Product / Process Change Notification (PCN)				
☐ Minor change				
PCN #:	PCN_WE-RCIT_20210621	Change Cate	gory:	
Affected Series:	WE-RCIT-Series 78471XXXX	_	t / Location	
PCN Date:	March 24, 2021	□ Process		
Effective Date:	June 21, 2021	□ Product Do⋈ Shipping /□ Supplier□ Software	esign Packaging	
Contact:	Product Management	Data Sheet C	hange:	
Phone:	+49 (0) 7942 - 945 5001	⊠ Yes	□ No	
Fax:	+49 (0) 7942 - 945 5179	Attachment:		
E-Mail:	pcn.eisos@we-online.com	□ Yes	⊠ No	
DESCRIPTION AND PURPOSE OF CHANGE: Due to internal standardisation, Würth Elektronik will change the packaging from bulk to plastic tray packaging for the parts 7847121100 and 7847131100. For the purpose of a datasheet information enlargement, Würth Elektronik will update and add information to the datasheets of the complete WE-RCIT-Series.				
All products with date code 2021-06-21 or later, will be affected by this change. There will be no change in form, fit, function, quality or reliability of the product.

DETAIL OF CHANGE:				
1. PACKAGING CHANGE 7847121100 AND 7847131100 To satisfy our internal quality requirements Würth Elektronik will replace the bulk packaging by the plastic tray packaging for the par

7847121100:

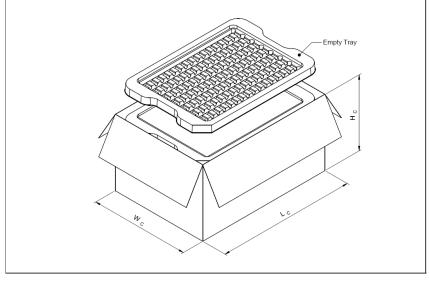
After the change:

112pcs/layer, 10 full trays in a carton → 1120pcs/carton

7847131100:

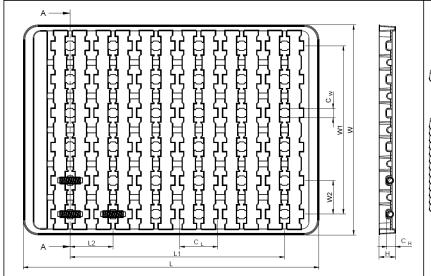
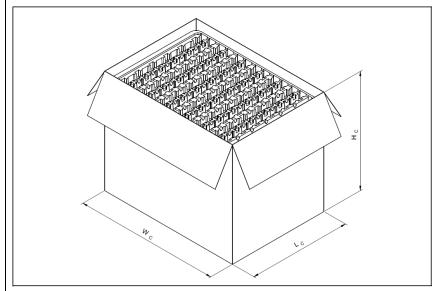
36pcs/layer, 13 full trays in a carton → 468pcs/carton

Typical Inductance vs. Current Characteristics:

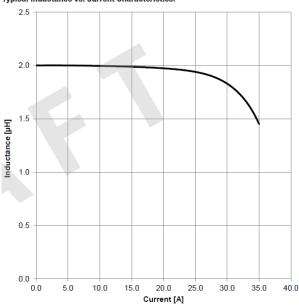
2.6 Updated "Typical Inductance vs. Current Characteristics" graph
